Good Shepherd Center Voluntary Seismic Retrofit Phase 1

Project #: 19011

BID SET - ADDENDUM NUMBER 3

ISSUED: March 25, 2024

Roof Framing Plan

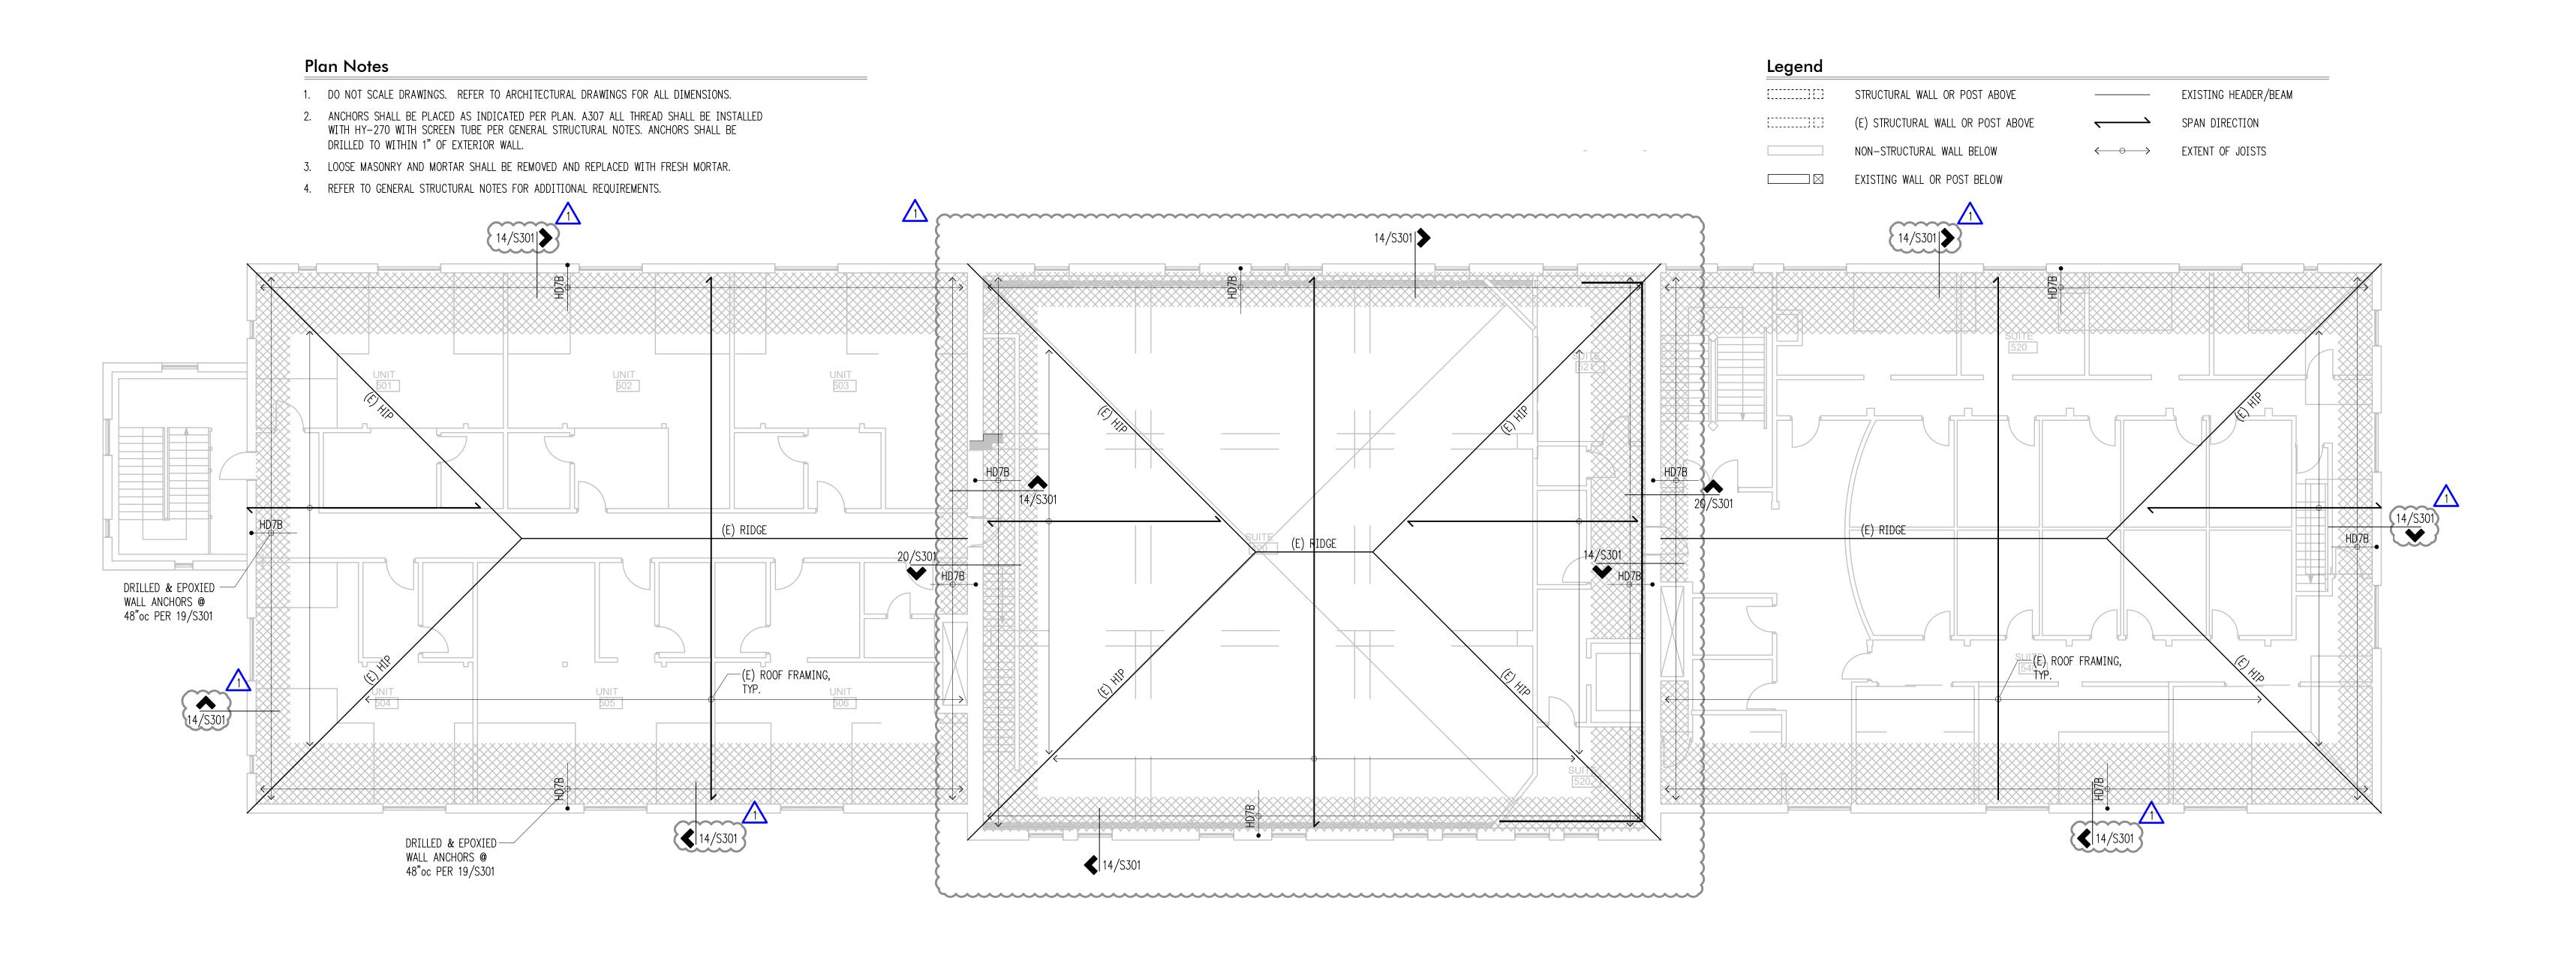
Question: Since there are no structural details shown on S202 (roof plan) related to the seismic upgrades of the roof on the main building are we to assume that only Details 19/20 floor joist apply to these locations and no seismic upgrades occur to the roof? If this is the case we will be removing the ceiling of the 3^{rd} and 4th floors not the 4^{th} (A204) and 5^{th} (A205) floors as shown.

Response: Structural detail 14/S301 applies to the roof line at level 5 of the Main Building, in addition to the South Annex roof. To clarify, out of plane anchoring scope in the Main Building comprises:

- 5th floor ceiling removal to connect roof to perimeter walls and fire walls (Add Alternate 1); see detail 14/S301.
- 4th floor ceiling removal to connect 5th floor to perimeter walls and fire walls (Add Alternate 2); see details 19/S301 and 20/S301
- Ceiling removal at chapel to connect roof to perimeter walls and fire walls (part of Add Alternate 3); see detail 14/S301.

See revised sheet S202 attached.
